CITY OF WAUKESHA

CITY
OF
WAUKESHA, WISCONSIN
AMERICANS WITH DISABILITIES ACT
TRANSITION PLAN
JULY 21, 1992

City of Waukesha
Self-Evaluation
Checklist

ELEMENT 3: RAMPS (ADAAG 4.8)

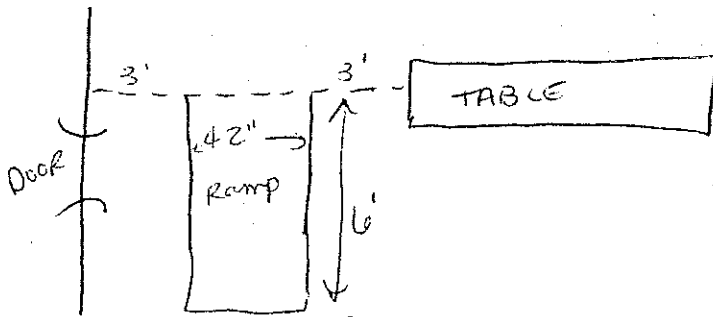
Comments: _____

Step is 6" high
